Statement of Environmental Effects Section 75W Application

Application No.: MP10_0189 (Sec 75J)

Application No.: MP10_0189 MOD 1 (Sec 75W)

Project: Residential Development- Stage 1, Figtree Building

Extract from Cox Richardson Plan A-PA-FP-A1 Revision 02 2012-05-10

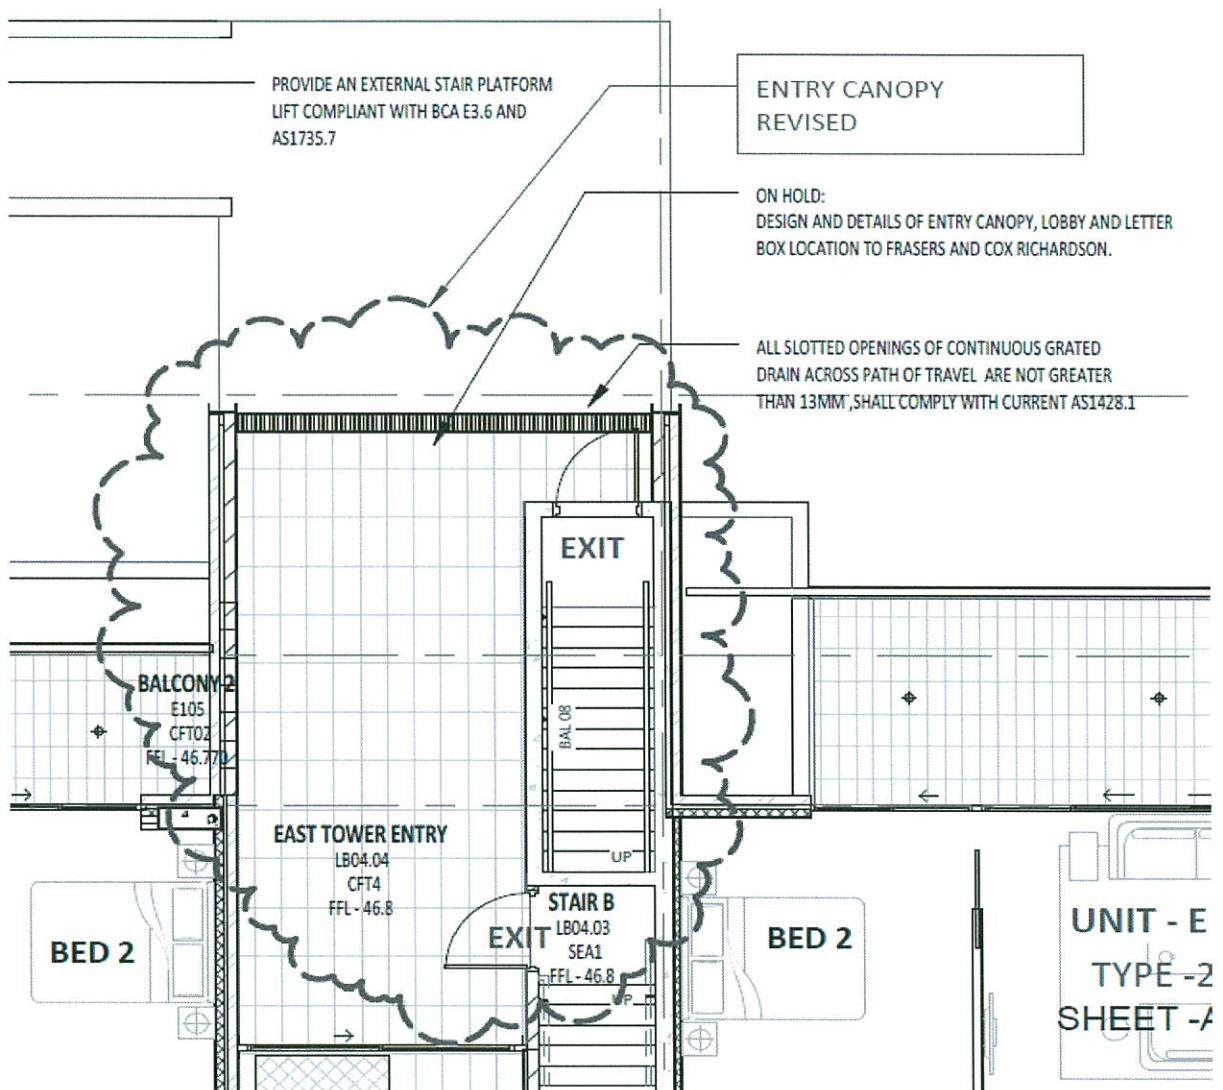
3.4.1 The entry Portico located at the North Eastern Corner of the property will not be constructed. The developer has opted to move the letterboxes previously located within the portico to the amended Entry Lobbies.

Entry Portico to be removed

Plan of Entry Lobby Canopy Revised
Extract from Australian Consulting Architects A-11A-2104 Issue A

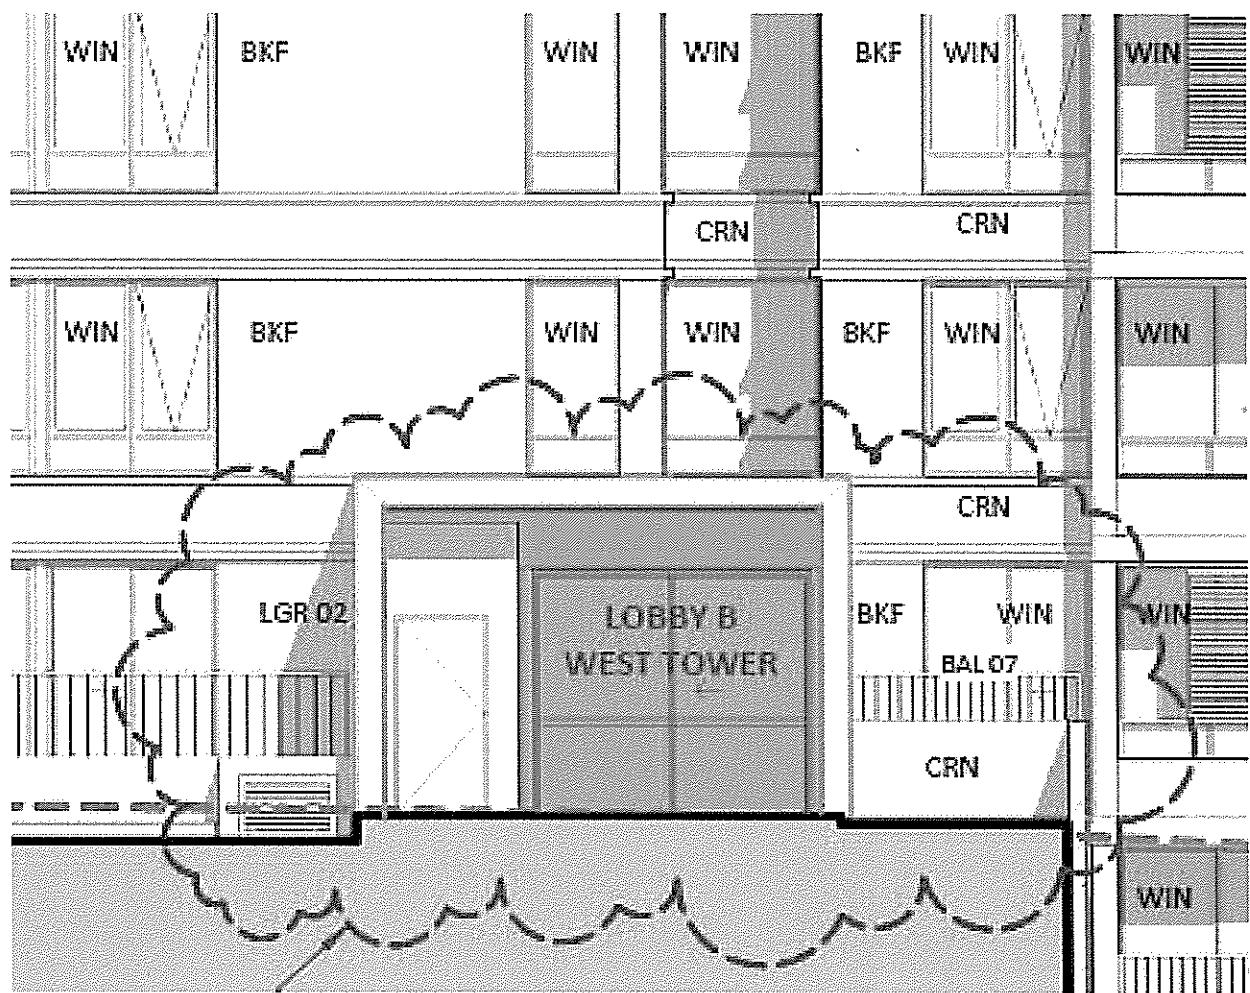
3.4.2 The 2 X Entry Lobbies located on the northern facade of the building have been amended to include an additional enclosing wall that letterboxes will be located within and the ceilings to the lobbies have been raked to increase the flow of smoke (in the event of a fire) in order to comply with a fire engineering solution.

Elevation of Entry Lobby Canopy Revised
Extract from Australian Consulting Architects A-11A-3002 Issue A

Balustrade, planter and ramped access amended
Extract from Australian Consulting Architects A-11A-3001 Issue A

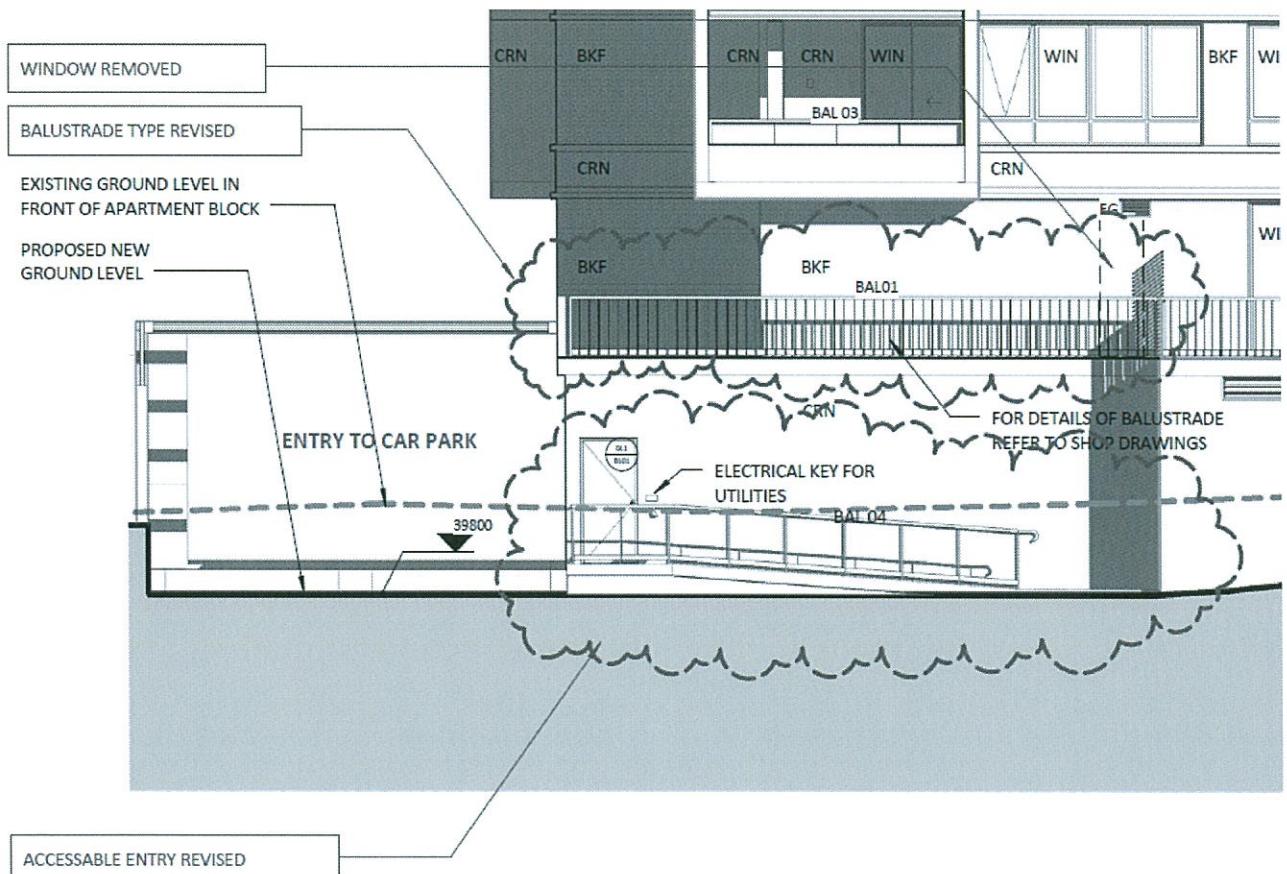
3.4.3 The balcony to unit 5A on the ground floor has been amended. The South Western Balustrade that was proposed as solid masonry has been changed to an open powder coated aluminium palisade style balustrade. A Planter box on the North West face that was also incorporated into this balcony space has been removed. There are no windows directly looking onto the new palisade handrail and the outlook from the balcony to the North West is onto a driveway below and an open space, therefore the amenity of the occupants of Unit 5A as well as the amenity of the surrounds is not impacted

3.4.4 The door on the Southern faced that provides egress from the basement bicycle storage area was relocated in order to achieve wheelchair access to the kerb side bin pickup area. A compliant ramp and required handrails was also added.
